FIXTURE AND POLE CHANGES

Sir Francis Drake Lighting Update

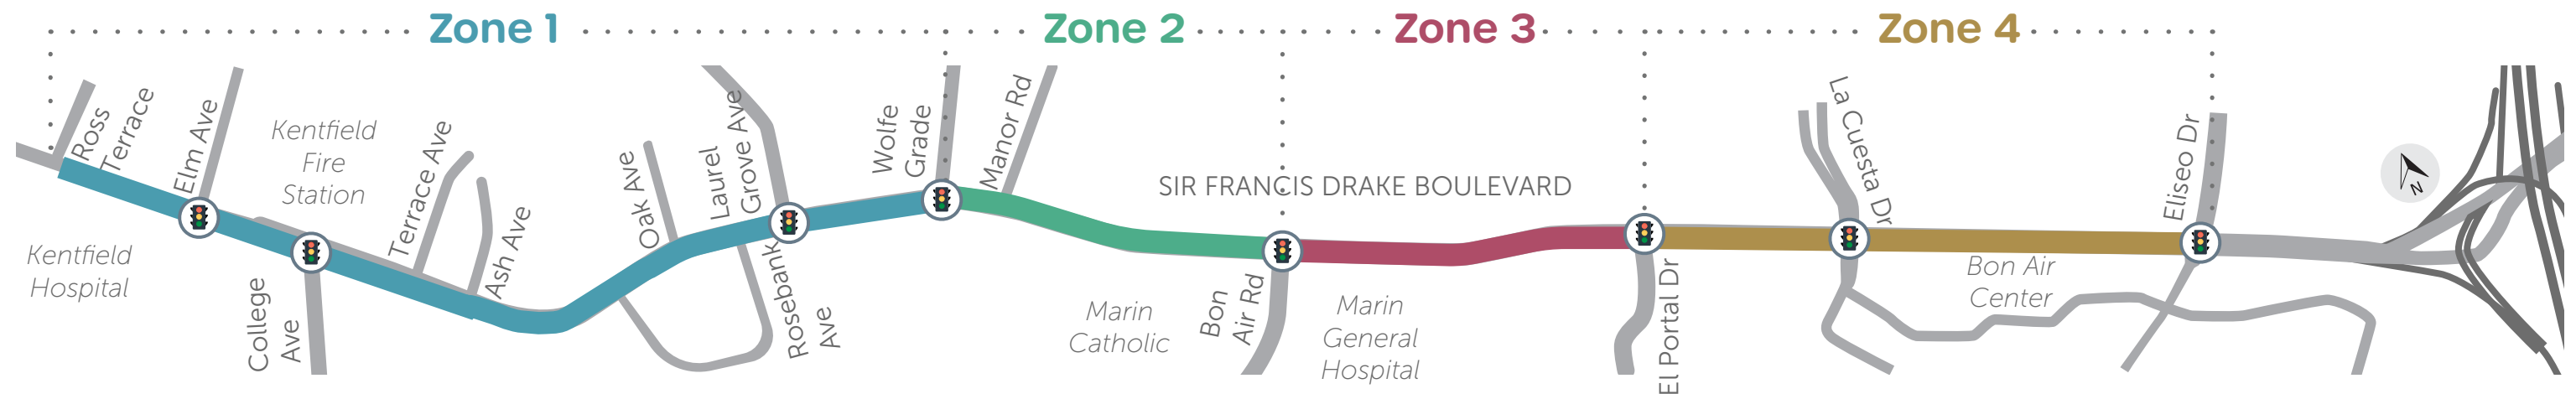
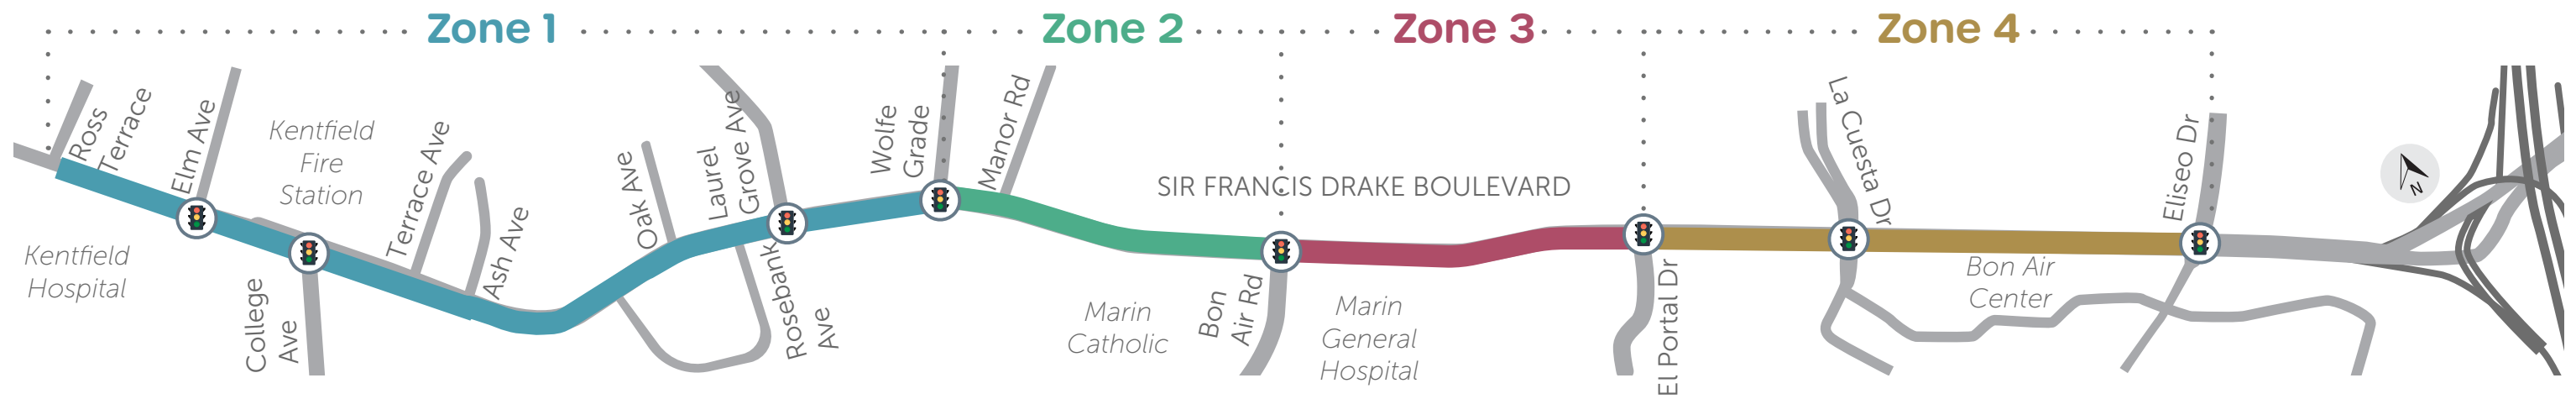
Based on our analysis and discussions with the County and community representatives, we recommend modifications to the recently installed roadway lighting. With our recommended changes, lighting poles and fixtures would be replaced along about one third of the corridor with shorter, decorative poles and fixtures. The shorter poles would require closer spacing to sufficiently and uniformly light the roadway, resulting in a net increase in total street lights. To reduce additional cost, the placement of these decorative poles would reuse light foundations already installed to the extent possible. The remaining light fixtures on the other two thirds of the project corridor, excluding intersection lighting, would be replaced with different fixtures that reduce overall brightness, improve consistency of light, and cast less light outside of the roadway and sidewalks. In addition, backlight shields would be installed on all sidewalk light poles to further minimize light spill into neighboring yards.

Replace **50** of **60** Cobrahead fixtures
All 44 poles remain

Replace **all 11** poles with Decorative fixtures and poles
+4 additional poles
Reuse **10** of **11** foundations

Replace **10** of **17** Cobrahead fixtures
All 9 poles remain

Replace **all 15** poles with Decorative fixtures and poles
+6 additional poles
Reuse **9** of **15** foundations

AVERAGE BRIGHTNESS OF LIGHT SPILLOVER

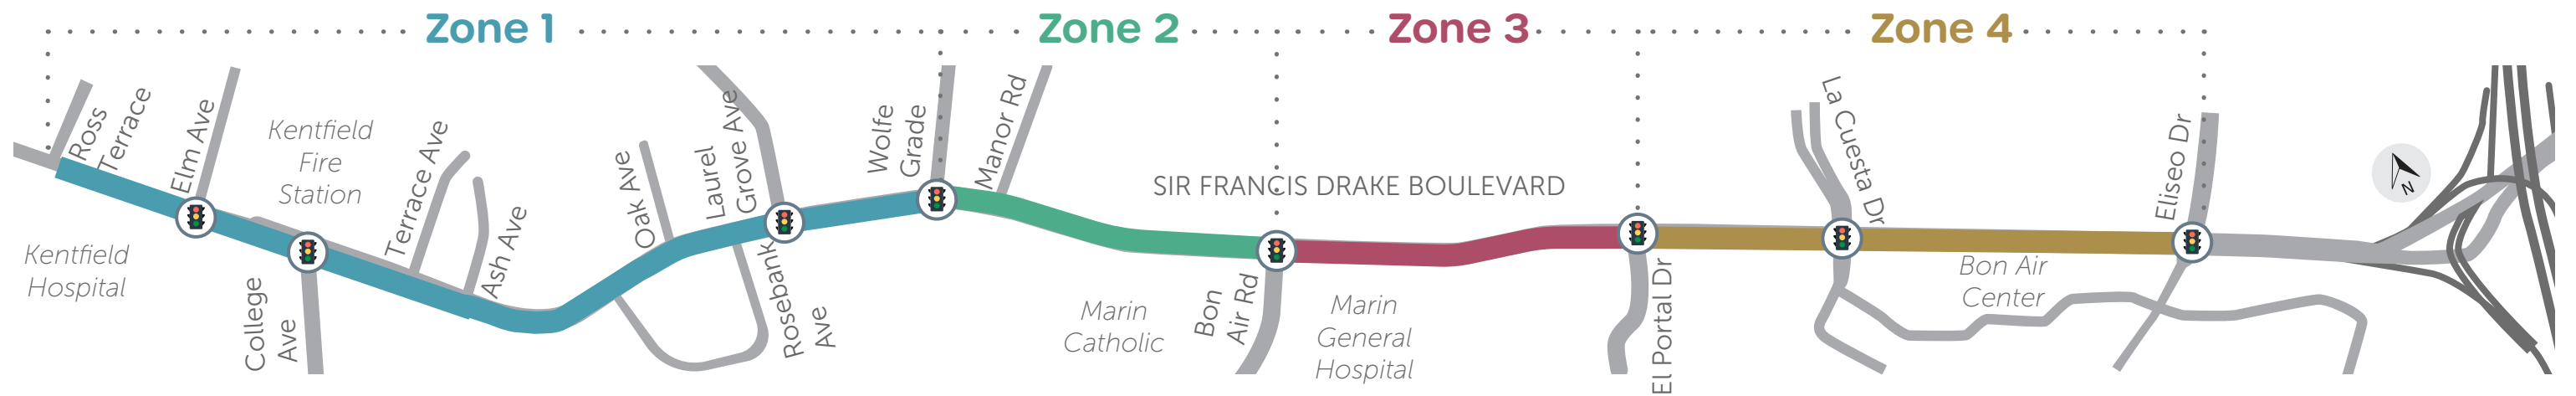
Light cast outside of the roadway and sidewalk should be **minimized**. Based on updated model results, the proposed improvements would reduce the average light spillover significantly – 37 to 75 percent, depending on the block analyzed.

Zone 1	Zone 2	Zone 3	Zone 4
Before Upgrade the Drake	N/A	N/A	N/A	N/A
Today <small>As-installed February 2021 with all lights on</small>	0.39 fc	0.32 fc	0.30 fc	0.45 fc
Proposed <small>Details may be refined during design phase</small>	0.21 fc 46% Reduction from today	0.20 fc 37% Reduction from today	0.16 fc 47% Reduction from today	0.11 fc 75% Reduction from today

AVERAGE ROADWAY BRIGHTNESS

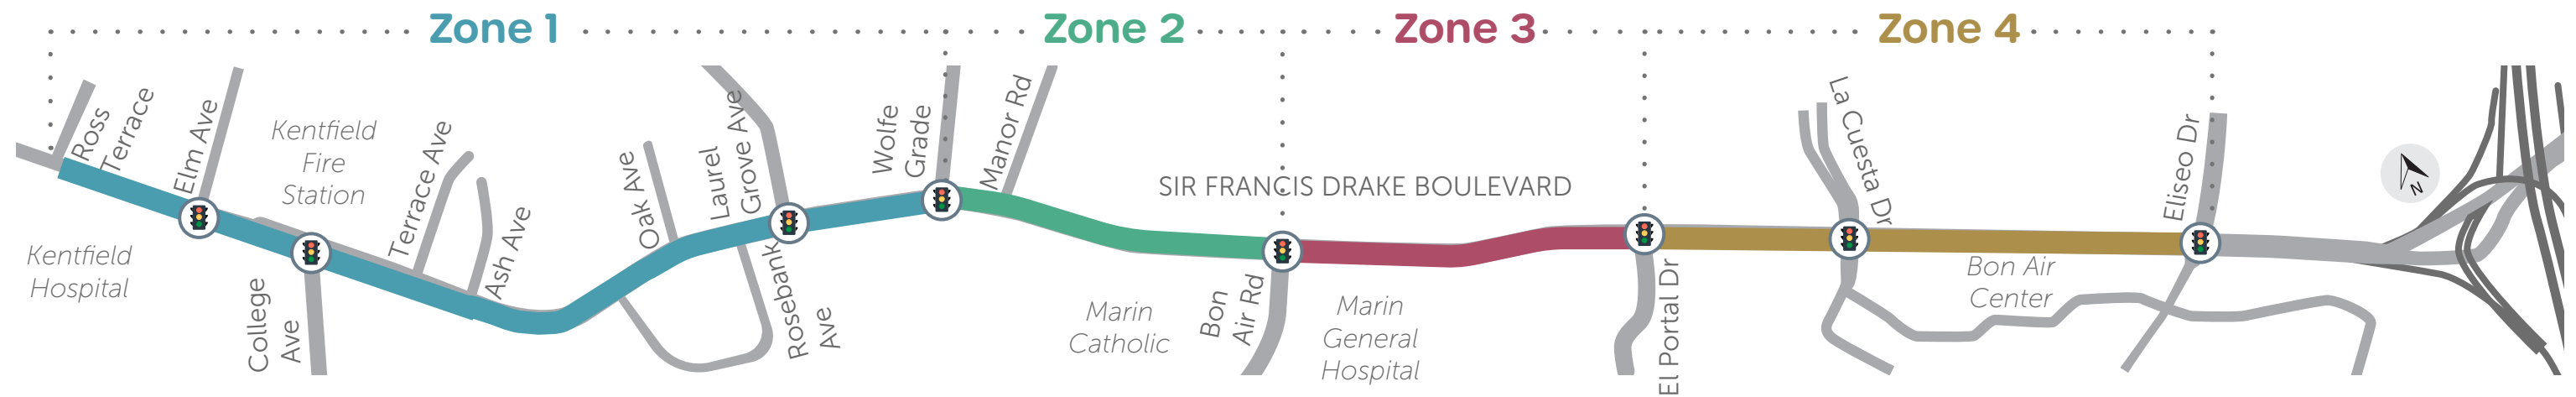
Lighting guidance suggests that roadways with characteristics like Sir Francis Drake Boulevard (Major asphalt roadway with low pedestrian activity) are lit with an **average of 0.9 foot candles (fc)** (ANSI/IESNA RP-8-00 Table 2). Before the Upgrade the Drake Project, light levels on the roadway were well below this, averages ranging from 0.2 fc to 0.8 fc. The Upgrade the Drake project installed lights that resulted in brightness levels with averages ranging from 1.2 fc to 1.5 fc. The Proposed modifications would reduce the average roadway brightness compared to the recently installed condition between 5 and 22 percent, resulting in lighting levels of 1.0 fc to 1.2 fc.

Zone 1	Zone 2	Zone 3	Zone 4
Before Upgrade the Drake	0.79 fc	0.19 fc	0.32 fc	0.18 fc
Today <small>As-installed February 2021 with all lights on</small>	1.48 fc	1.32 fc	1.24 fc	1.31 fc
Proposed <small>Details may be refined during design phase</small>	1.16 fc 21% Reduction from today	1.19 fc 10% Reduction from today	1.16 fc 6% Reduction from today	1.02 fc 22% Reduction from today
